**City of Pembroke Pines**  
**Planning & Economic Development Department**  
**601 City Center Way 3<sup>rd</sup> Floor**  
**Pembroke Pines FL, 33025**

<b>Agenda Date:</b>	June 27, 2019	<b>Application ID:</b>	MSC 2019-10
<b>Project:</b>	Panera Bread Tenant Modifications	<b>Project Number:</b>	N/A
<b>Project Planner:</b>	Cole Williams, Planner / Zoning Technician		
<b>Owner:</b>	Pembroke Lakes Square, LLC c/o Retail Property Group, Inc.	<b>Agent:</b>	Phillips   Sekanick Architects, inc.
<b>Location:</b>	11025 Pines Boulevard		
<b>Existing Zoning:</b>	B-3 (General Business)	<b>Existing Land Use:</b>	Commercial
<b>Reference Applications:</b>	MSC 2018-18, SP 2012-08, MSC 2007-66, MSC 2006-48, SP 2005-06 ZC 2005-02, ZC 2001-02, SUB 2001-01		
<b>Applicant Request:</b>	Modifications to the existing drive-thru lane and canopy, existing store front, and the existing outdoor seating area		
<b>Staff Recommendation:</b>	<b>Approval</b>		
<b>Final:</b>	<input checked="" type="checkbox"/> Planning & Zoning Board	<input type="checkbox"/> City Commission	
<b>Reviewed for the Agenda:</b>	Director: 	Planning Administrator:

## **PLANNING DIVISION STAFF COMMENTS**

#### CLEARANCE BAR SIGN

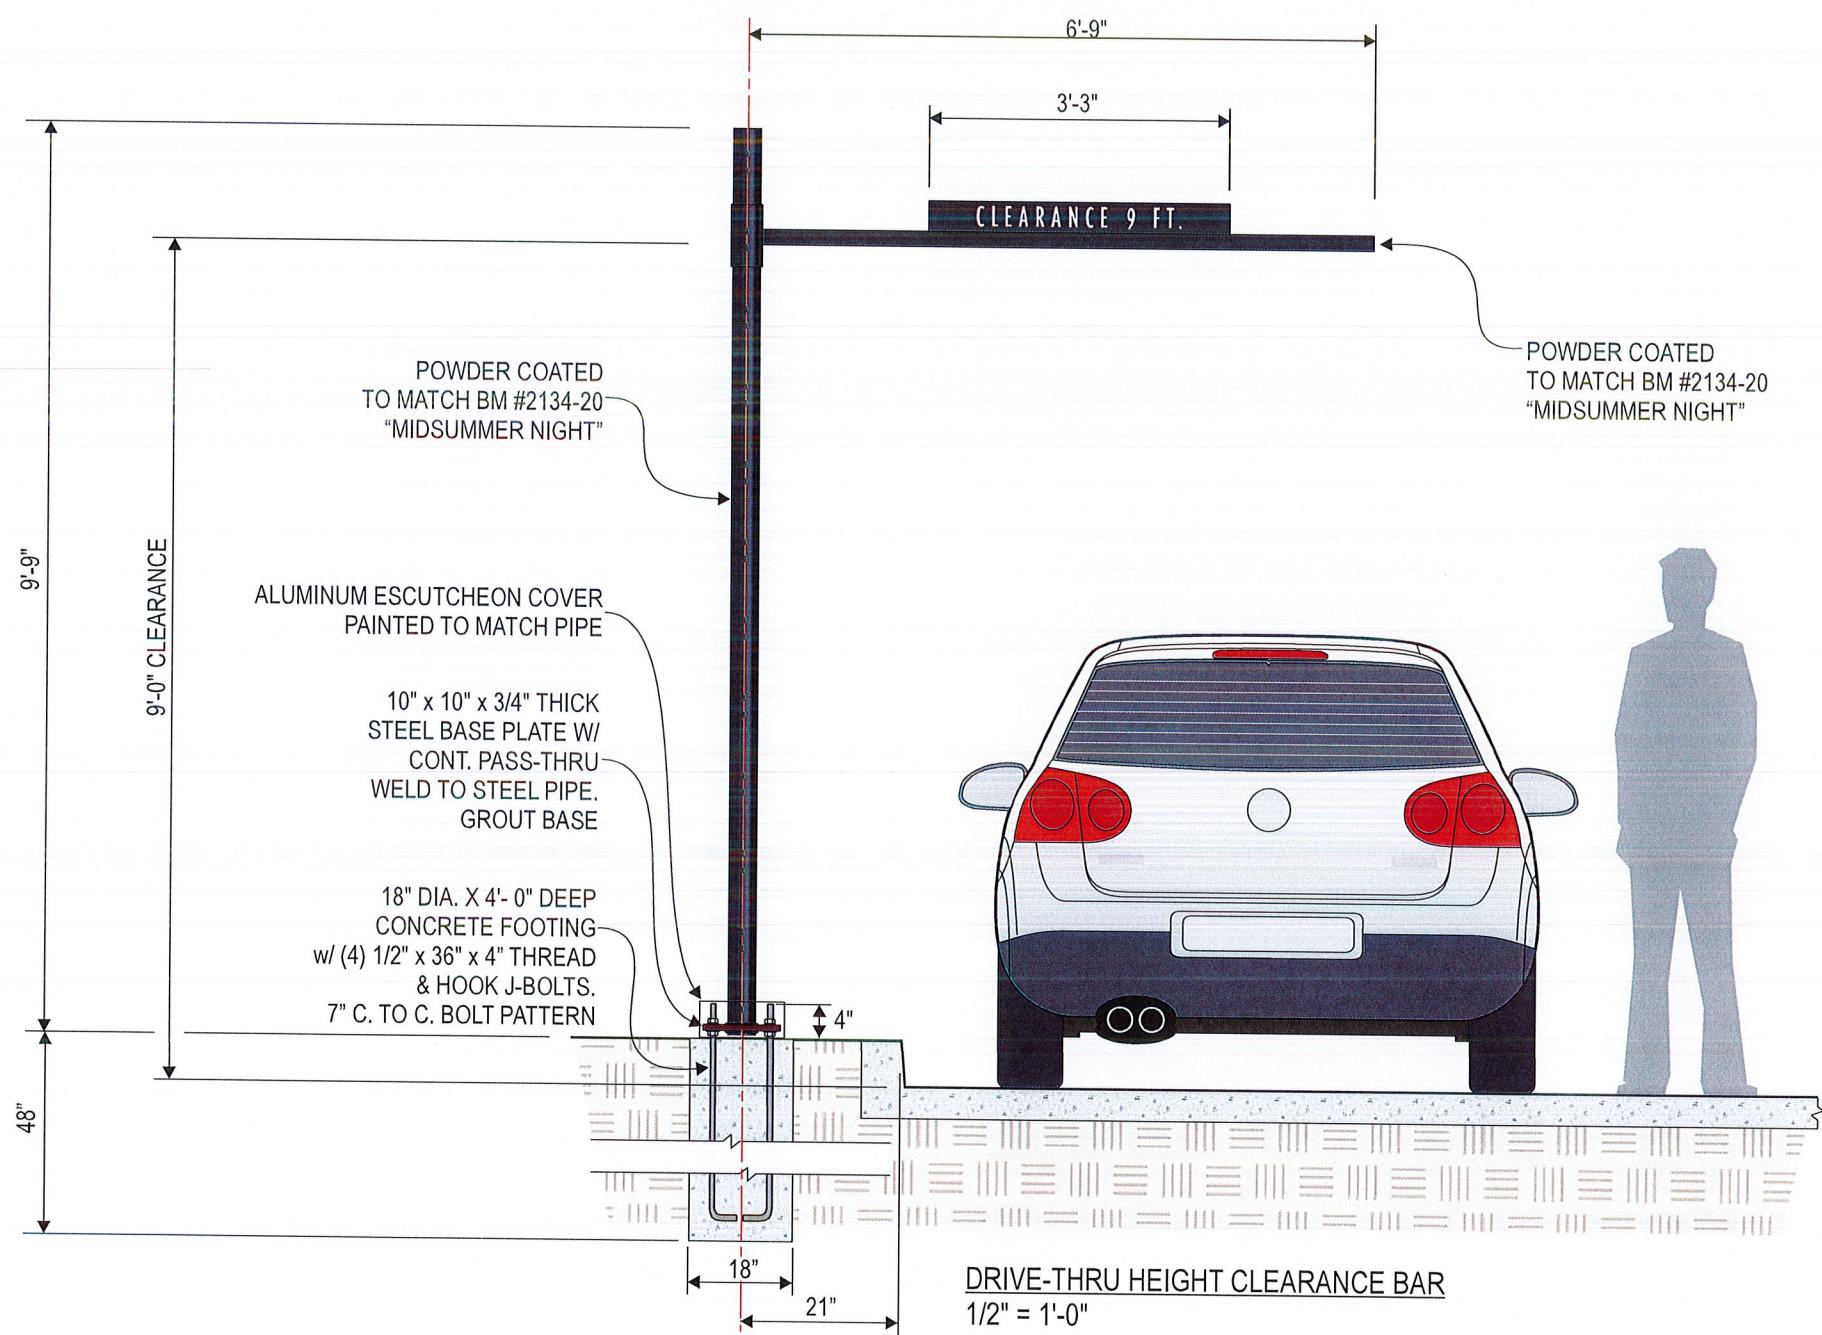
1. Provide elevations, with all details, dimensions, etc. of menu board, ordering equipment, canopy and clearance bar. No
2. Only one menu board allowed.
3. Will there be any directional signs (e.g. Drive Thru w/ arrow, exit, etc.)? If so, show location(s) on Site Plan and provide elevation(s) showing details and dimensions. Signs are a maximum of 1.5 sq. ft. and cannot have name/logo on them.
4. Provide note on north elevation that color of wall repaired from removal of bank drive thru canopy will match existing and/or that entire wall may need to be repainted due to fading.
5. Provide color name, color number, finish, etc. of new canopy above drive thru window.
6. Provide detail elevation of railing being added in rear of building.

## Drive Thru Directional Sign

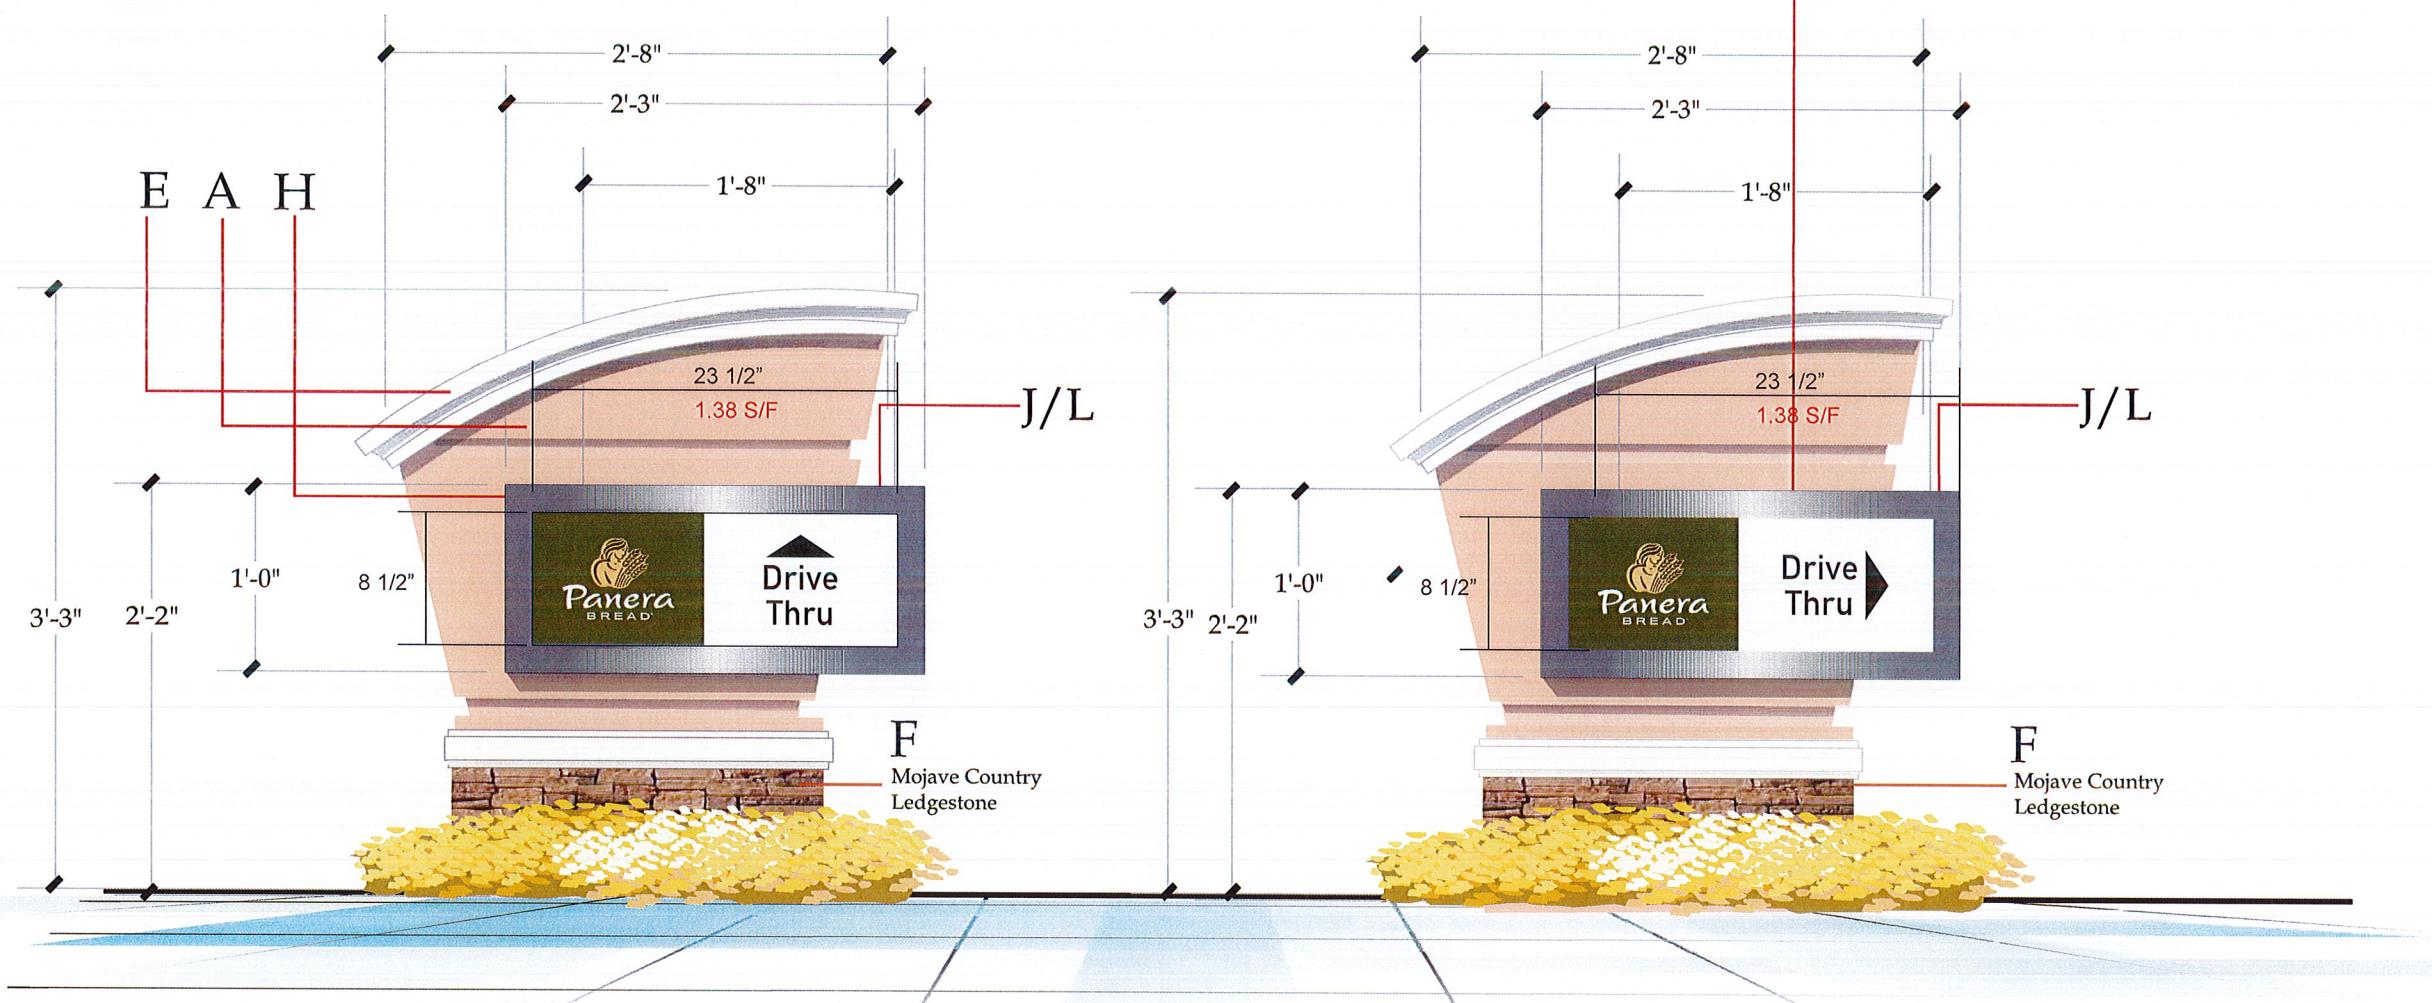
3. Provide details of directional signage. Signage to not exceed 1.5 square feet. **The copy on the signage cannot exceed 1.5 square feet. Directional Signage #21 and #25 is not existing and would not be permitted unless other directional signs on site are removed.**
